2017 Ford Mustang V8-5.0L

5.0L - Oil Leaks From Valve Cover Gasket

19-2309

16 October 2019

Figure 2

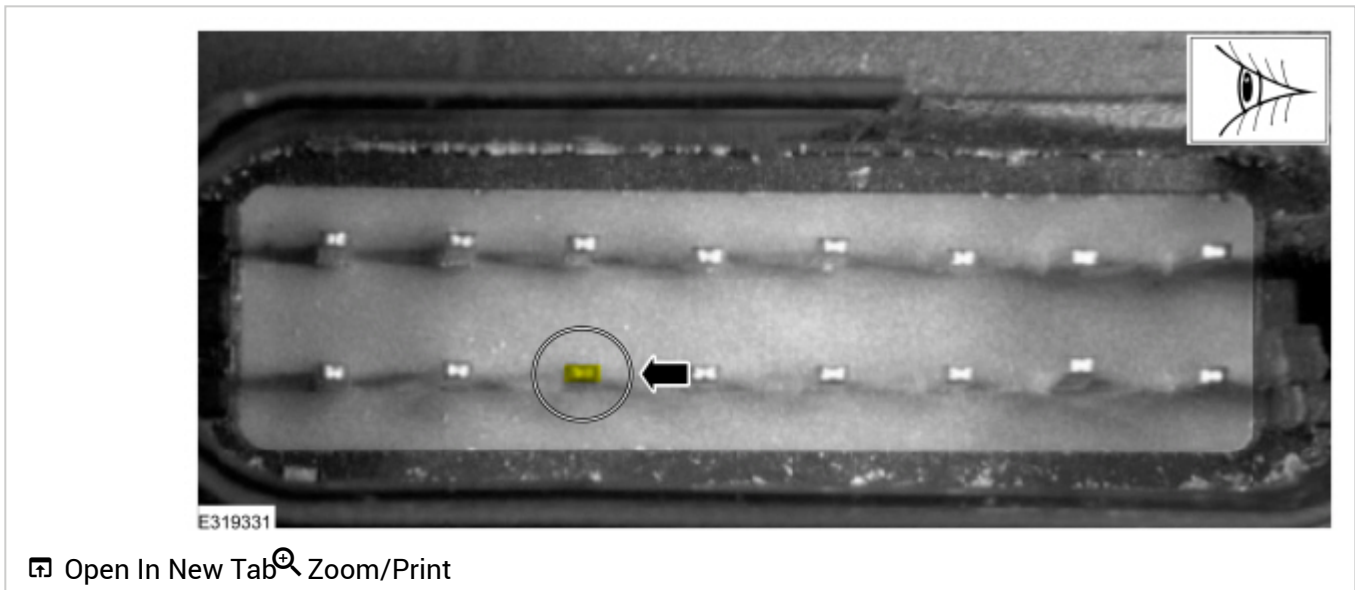
3. Reinstall the valve covers onto the engine, adding fasteners through the holes drilled in Step 2. Refer to WSM, Section 303-01C. Follow the revised tightening sequence in Figure 2 for the left valve cover and Figure 3 for the right valve cover. Tighten the fasteners to 10 Nm (89 lb-in).
